SUBJECT: **DEMONSTRATION / DELIVERY HOLD - Safety Recall 16S13 - Supplement #1**
 Certain 2015-2016 Model Year Transit Wagon Vehicles with Low Roof
 Side Curtain Airbag Inspection and Adjustment

REF: **DEMONSTRATION / DELIVERY HOLD - Safety Recall 16S13**
 Dated May 5, 2016

New! REASON FOR THIS SUPPLEMENT

FIGURE 1

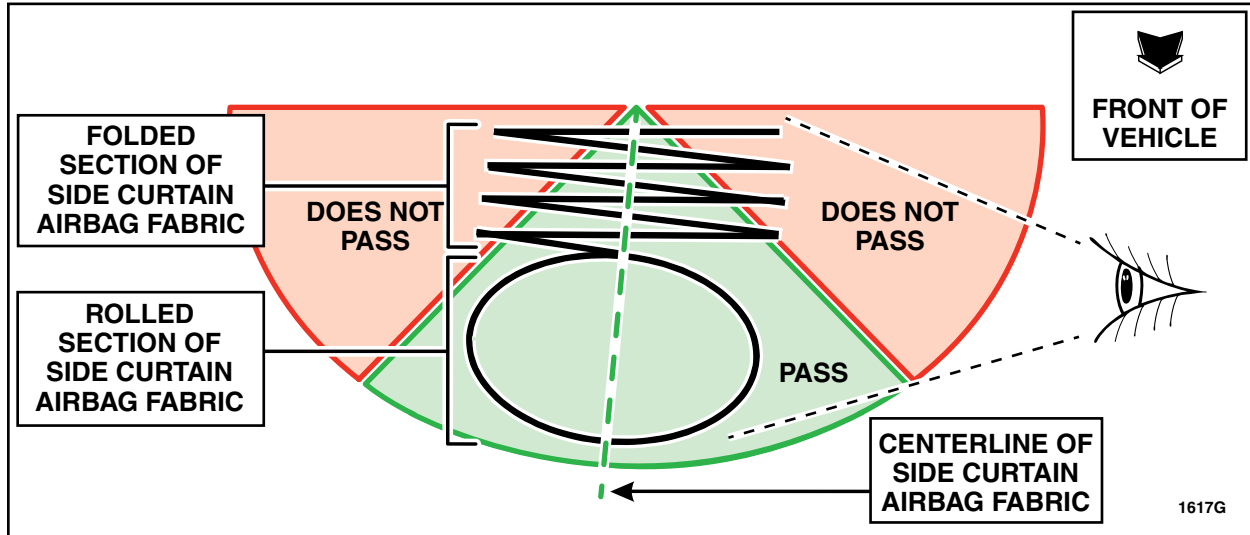
2. Inspect the driver and passenger side curtain airbag fold orientation starting at the B-pillar and ending at the rear of the vehicle. When properly positioned, the centerline of each side curtain airbag will have a rolled section of side curtain airbag fabric that should be positioned below the folded section. The side curtain airbag fabric orientation may be positioned anywhere within the acceptable (**PASS**) range illustrated in Figure 1.

FIGURE 2

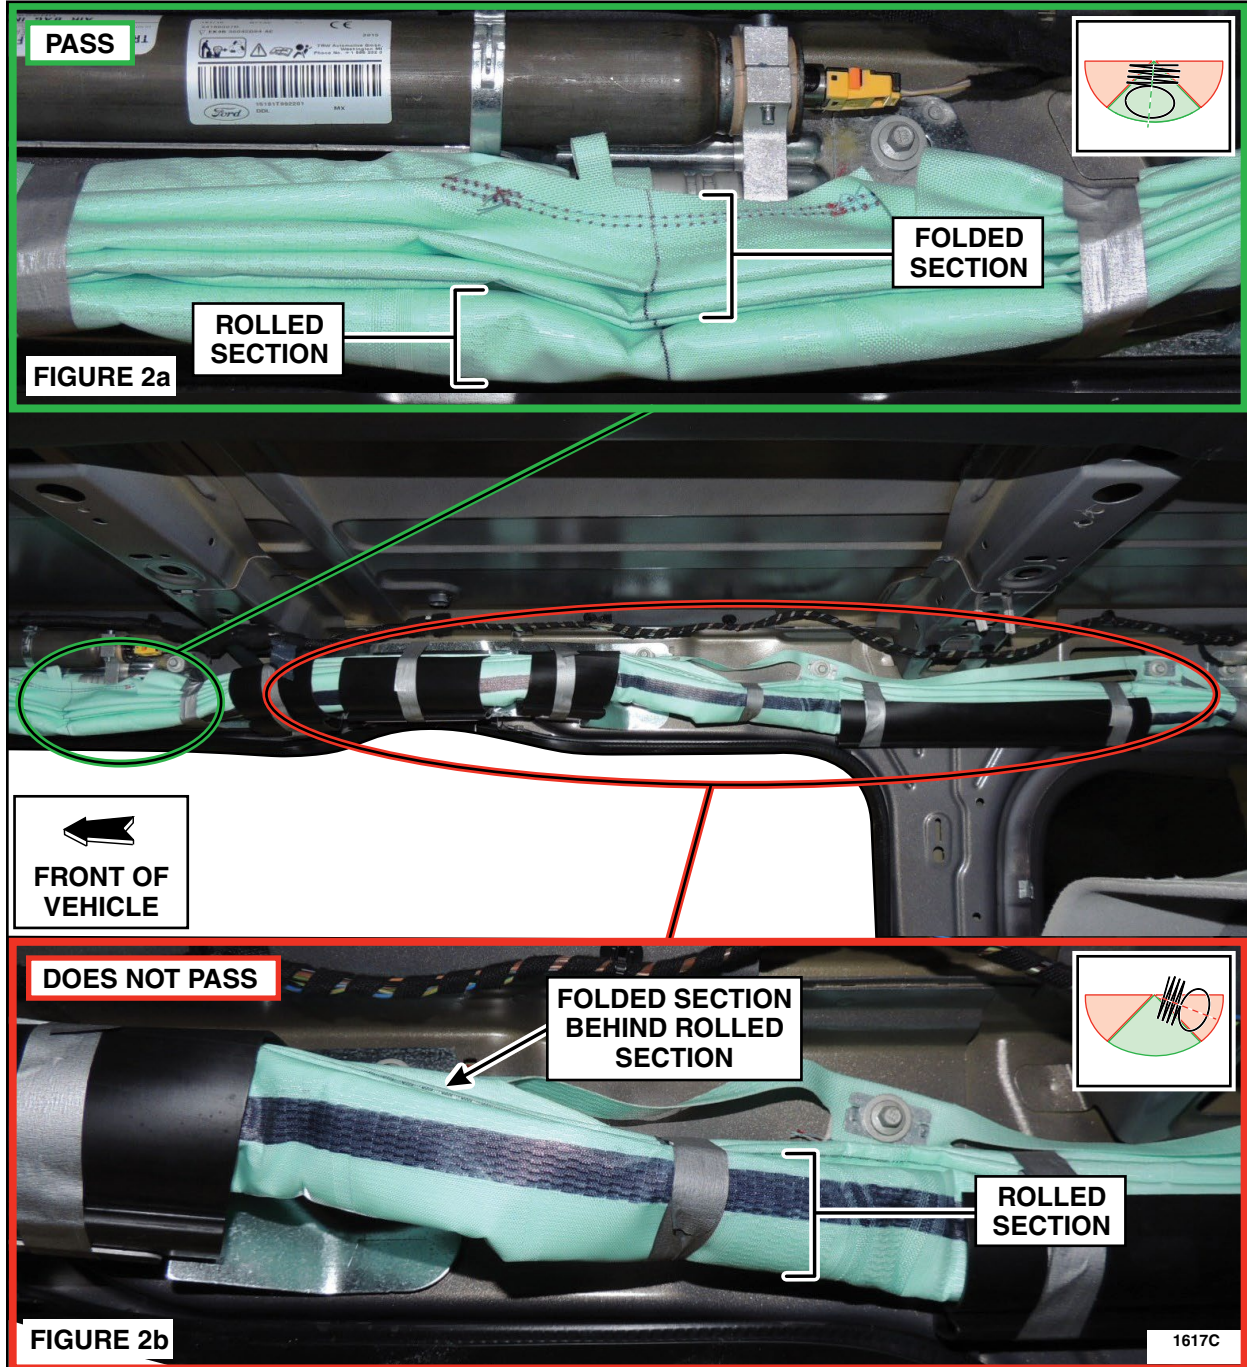
The side curtain airbag **PASSES** inspection if the centerline of the rolled and folded sections is within the acceptable (**PASS**) range. See Figure 1 and 2a. If both the driver and passenger side curtain airbags pass inspection, the repair is complete. Install the rear headliner sections. Please follow the WSM procedures in Section 501-05 (rear headliner).

The side curtain airbag **DOES NOT PASS** inspection if the centerline of the rolled and folded sections is **not** within the acceptable (**PASS**) range at any point rearward of the B-pillar. See Figure 1 and 2b. If the side curtain airbag does not pass inspection at any point rearward of the B-pillar, proceed to the Side Curtain Airbag Adjustment Procedure on Page 3.

FIGURE 4

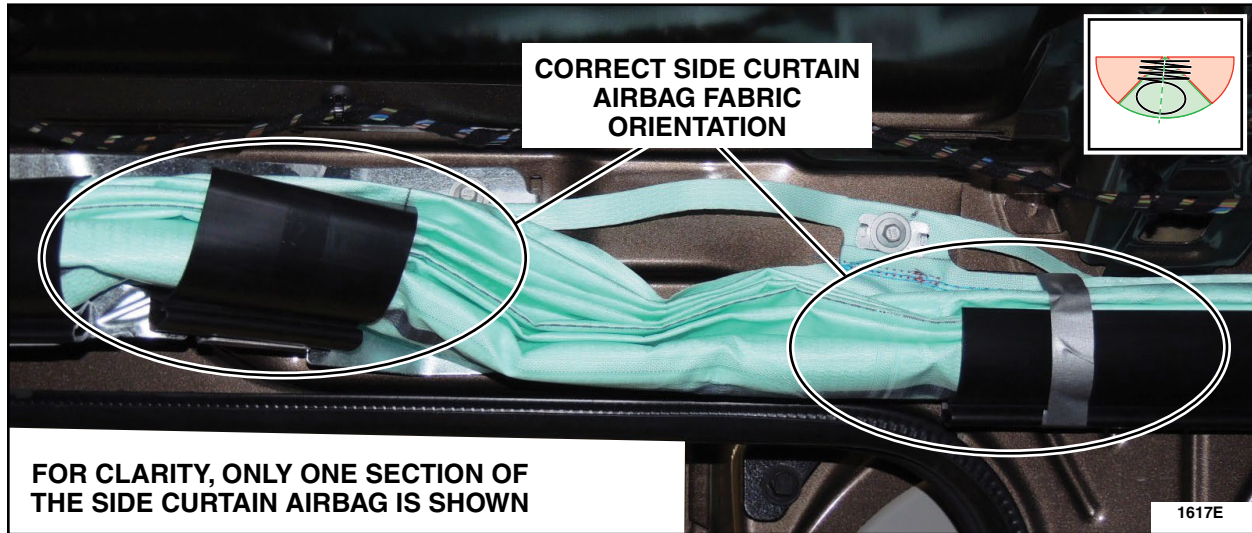
4. For all portions of the side curtain airbag that **DO NOT PASS** inspection, adjust the side curtain airbag fabric to match the correct orientation shown in Figure 4.

FIGURE 5a

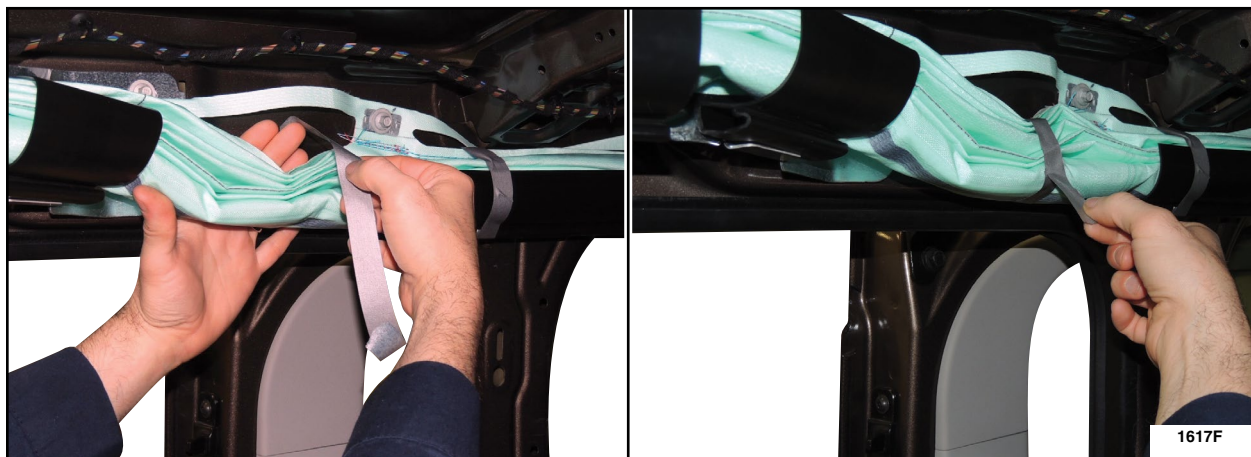
5. For each of the side curtain airbag tape pieces removed from the factory locations, cut a 10 in (25.4cm) piece of side curtain airbag tape from the roll. Route the side curtain airbag tape above the side curtain airbag fabric, going fully around, and overlap the side curtain airbag tape ends at the bottom to secure the fabric. See Figure 5a and 5b.

NOTE: To guide the side curtain airbag tape above the side curtain airbag fabric, place one hand behind the fabric and stick the side curtain airbag tape to one finger. Carefully remove your hand while guiding the side curtain airbag tape above the fabric. See Figure 5a.
